North East Link Project, Environmental Effects Statement

Peer Review - Urban Design

Urban Design Evidence prepared by Craig Czarny, Hansen Partnership
July 2019, on behalf of the Cities of Banyule, Boroondara, Manningham & Whitehorse

The expansive character areas as set out in the UDS.

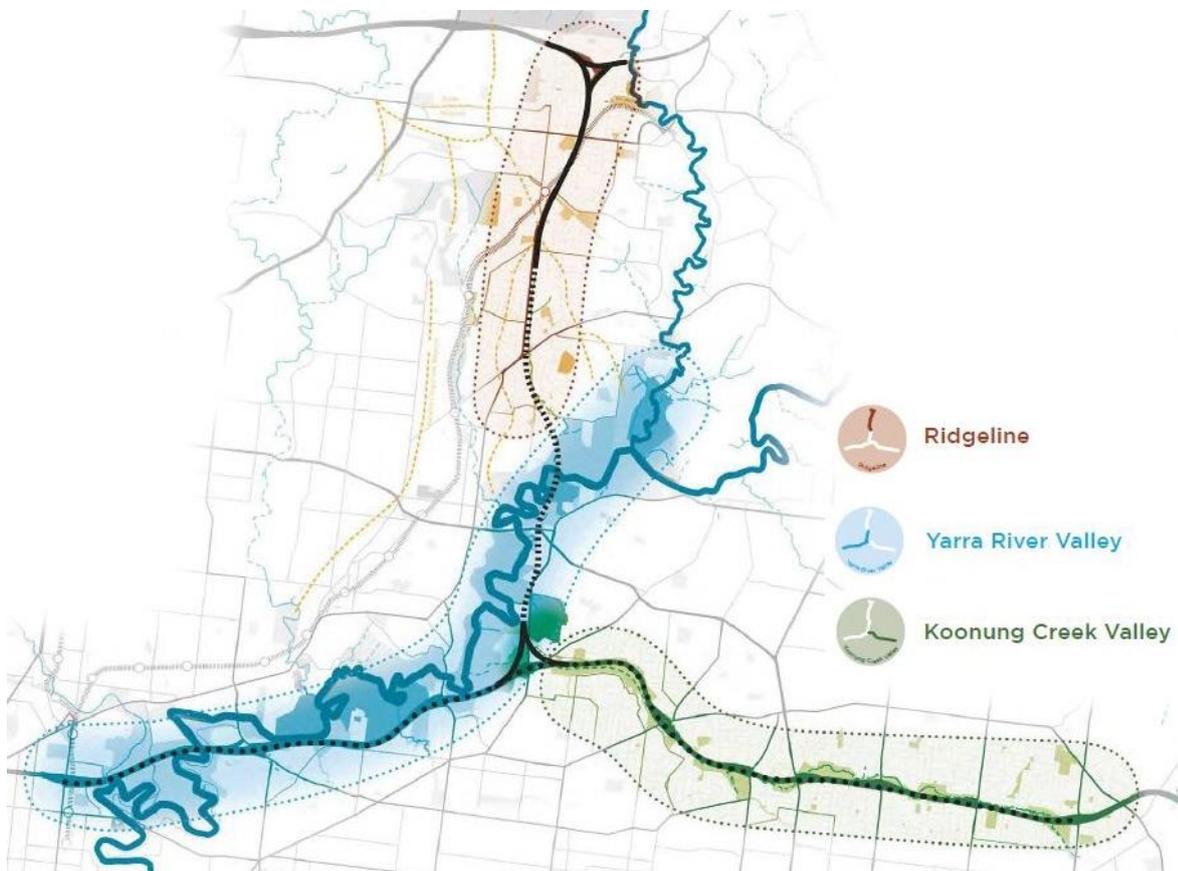
20. A particularly 'loose fitting' component of the UDS is the 3 defined 'character areas' which the document uses to navigate across its extensive footprint. These are Ridgeline, Yarra River Valley and Koonung Creek Valley. While these comprise generally accurate descriptions of large landscapes, their scale does not correspond to the discrete nature of varied urban and natural conditions along the length of the corridor. This approach in itself diminishes the opportunity for the Project to respond well to local contexts. In my opinion, a more thorough and deeper understanding of the range of local contexts and characteristics along the proposed Project alignment is required – that has regard to the entire visual and experiential threshold of the initiative. This would result in more 'granular' place-specific design requirements to be entrenched in the Reference Design.

23. While the above Principles, Objectives and Directions are undeniably relevant as tests, I have serious concerns that the generic content of the UDS and its parts will have a 'trickle-down effect' on competent evaluation of the total Project. This is particularly notable when considering the weight given to the UDS in the Incorporated Document and/or its role as a default EPR for most Risks (identified in EES Attachment III – Risk Report) which states 'EPR LV1 – Design to be generally in accordance with the UDS'. The use of vague terminology like "generally in accordance with" in my opinion limits the capacity for proper quantitative or qualitative assessment of the Reference Design against the UDS. I would suggest stronger commitment to the UDS in this instance.

Watsonia NAC Precinct ID

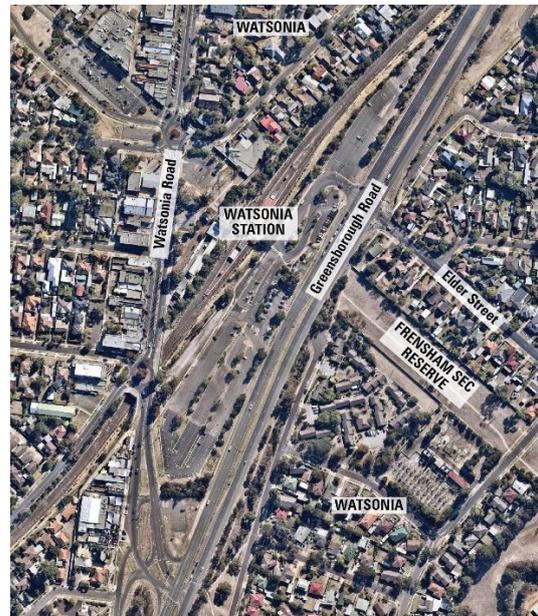
41. The Watsonia Neighbourhood Activity Centre (NAC) is an important local commercial and community node anchored by Watsonia Road retail core, Watsonia Railway Station and the alignment of Greensborough Road. Greensborough Road in this locality presents as a wide vehicular dominant space, accentuated by the expansive at-grade commuter car park serving the Station and somewhat alienated residential land to the east. This area is largely disconnected from the Watsonia Road – ‘Main Street’ to the west. The breadth of linear infrastructure in the precinct severs the Centre into a series of disparate parts.

47. Many (if not all) of the above concerns could be addressed if the Project was designed within a tunnel (in a number of different formats) through this district (as tabled in EES Chapter 6: Project Development – Part 6.4.1 Option A) thereby providing the opportunity for seamless connectivity between neighbourhoods to either side of Greensborough Road and 'stitching together' the Watsonia NAC. As is widely acknowledged, tunnel initiatives of this kind (including cut and cover) also provide the opportunity for Land Value Capture development initiatives, which are entirely apt within the Watsonia NAC in association with the Railway Station precinct - and assist in supporting 'non-farebox' revenue if required.

Estelle Street, Bulleen – ID

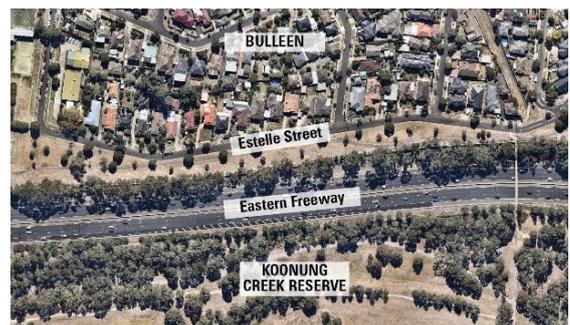
87. While the Creek corridor to the south of the Freeway is sometimes wide, the north interface is 'tighter' and abuts residential streetscapes, particularly between Bulleen Road and Tram Road. The residential interface condition varies from direct abutments (e.g. Stanton Street, Doncaster) to streetscapes that generally contains 'borrowed landscape amenity' from the Koonung Creek Linear Reservation at the north edge of the Freeway (e.g. Estelle Street, Bulleen).
